INDESIT company

BAAN33VPS

F034200

51520P0 Exploded views

N1030093fig1

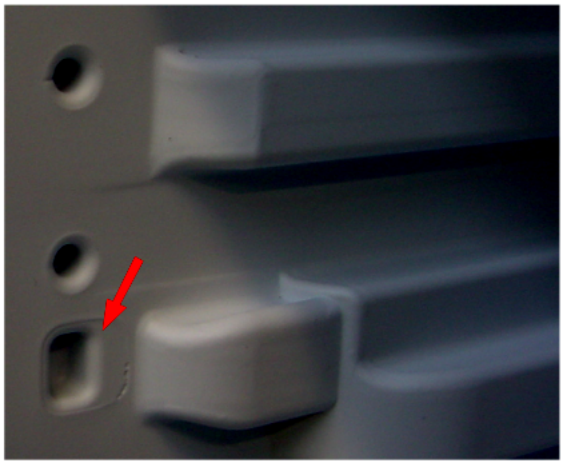
n1030093: New fixing of evaporator on static fridge-freezers (05 range) 60 cm,Melano

From August 05 (serial no. 50802.0001) the freezer evaporator is secured to the cabinet by a plastic profile.
The cabinet walls have been modified to create locations to house the profile, which is installed on the front of each evaporator plate (see photo N1030093fig1- fig2 - fig3)
The profile cannot be fitted on premodification appliances, so technical personnel must continue to fit the rh and lh supports on these models (see photo N1030093fig4)

New parts
C00141135 = WHITE PROFILE L=443.5 MM

Parts replaced
C00075596 = EVAPORATOR RH SUPPORT
C00075597 = EVAPORATOR LH SUPPORT

N1030093fig1

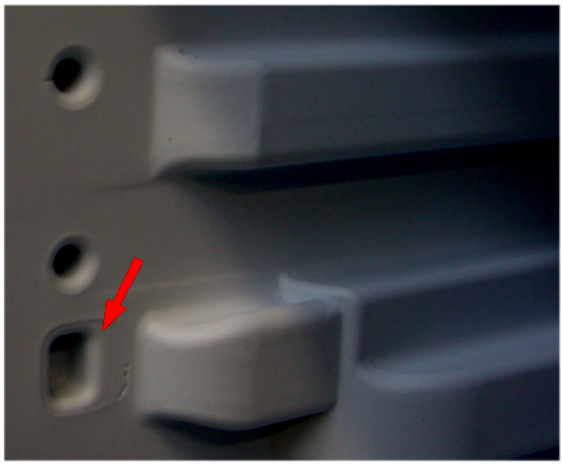
n1030094: New fixing of evaporator on static fridge-freezers (05 range) 60 cm, Lodowek

From August 05 (serial no. 50820.0001) the freezer evaporator is secured to the cabinet by a plastic profile.
The cabinet walls have been modified to create locations to house the profile, which is installed on the front of each evaporator

plate (see photo N1030093fig1- fig2 - fig3)
The profile cannot be fitted on premodification appliances, so technical personnel must continue to fit the rh and lh supports on these models (see photo N1030093fig4)

New parts
C00141135 = WHITE PROFILE L=443.5 MM

Parts replaced
C00075596 = EVAPORATOR RH SUPPORT
C00075597 = EVAPORATOR LH SUPPORT
